Please see below, pre-app advice in relation to proposals for alterations to the property at 33 Willoughby Road, initially received 24/08/2021, and with the latest revised drawing received 24/11/2022.

2021/4089/PRE

33 Willoughby Road

Relocation of the front door, replacement glazing and external refurbishment of the house.

Image 7. (Left) Part side elevation EL2, (Right) Google street view close up of upper bay.

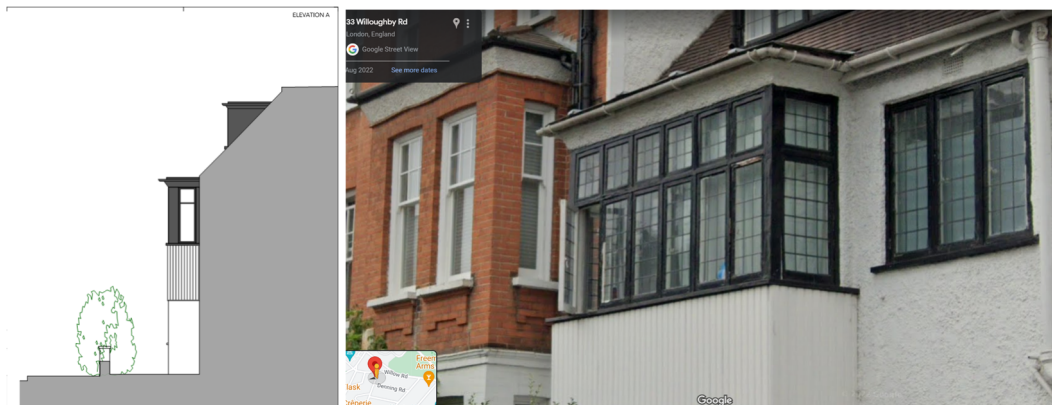
8.4 The remaining issue with EL2 relates to the upper bay window which is shown with a dark grey material surrounding the black window frames. As per the lower part of the bay and the existing arrangement, this area would also benefit from white render. This detail can also be seen on the part side elevation and google street view imagery provided below:

8.5 Also to note, the proposed alteration to the front roof dormer cheeks has been designed to match the proposed upper bay, as shown in EL2; however given the issue with regards to the upper bay described in para 8.4 above, this element may also need some revision. For the avoidance of doubt it would be preferable to match the existing dormer design arrangement as closely as possible.

between ground floor and 1st floor bay windows, although shown in greater detail on the proposed drawing EL2, this is in fact as per the existing arrangement (see google street view above in image 7) and would remain as is subject to like for like repair and replacement.
